APPEAL SUMMARY

Appeal ID: 24525	Project Address: 900 SW Washington St
Hearing Date: 1/20/21	Appellant Name: Steven Rupert
Case No.: B-004	Appellant Phone: 5033176573
Appeal Type: Building	Plans Examiner/Inspector: Katherine Aulwes
Project Type: commercial	Stories: 35 Occupancy: S, A, B, M, R Construction Type: I-A
Building/Business Name: Block 216	Fire Sprinklers: Yes - Throughout
Appeal Involves: Erection of a new structure, Reconsideration of appeal	LUR or Permit Application No.: 19-130673-CO
Plan Submitted Option: pdf [File 1] [File 2]	Proposed use: Mixed Use Retail, Hotel, Office, Condominium Building

Appeal item 1

SIGN AT MAIN ENTRANCE/EXIT OF CLUB LOUNGE:

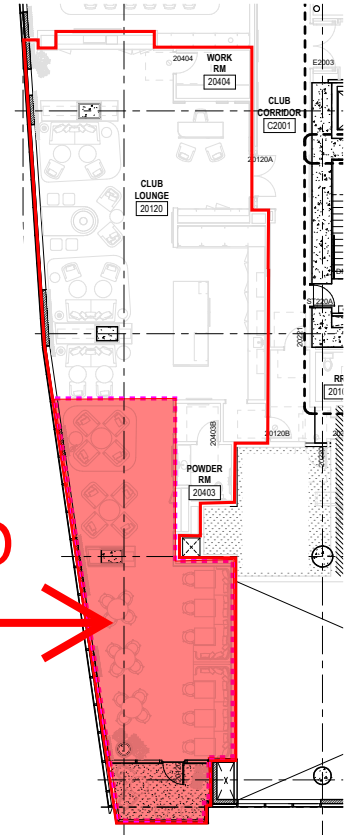
An occupancy load sign will be posted at the Club Lounge Entry as required for assembly occupancies per OSSC 1004.3. In addition to indicating the overall club lounge occupant load this sign will be provided with a plan graphic for the lounge that highlights the partial Seating Area, Reading Room and Terrace with a limitation of 49 occupants for that area (see attached figure).

A sign will also be posted on the wall at the north end of this area noting that the occupant load for the area south of the sign is limited to 49 occupants (see attached figure).

The width at the north end of the seating and reading room area in question does not exceed 13rd of the overall diagonal. However, we believe the occupant load of this area should not require two exits and therefore a narrower dimension should be found acceptable. Due to the intended use of the club lounge amenity as required by the hotel operator's program, the occupancy of this area will be much lower than the result of the common 1/15sf calculation for A-3 occupancies. The capacity of the seating arrangement as shown for this area is also reflective of this lower occupant load anticipation. If a restriction of 49 occupants is applied to this area, only one exit is required. By posting signage indicating this limitation all staff of the hotel operator who control access to this lounge and manage the use of this area will be well informed of this limitation. Having the occupant load limit posted directly north of the space in addition to a graphic indication on the primary occupant load sign for the Club Lounge will reinforce an understanding of this limitation.

1. Increase in maximum allowable common path of egress travel from 30 feet to 57 feet: Granted as proposed.

2. Determination of exit access separation: Granted as proposed.
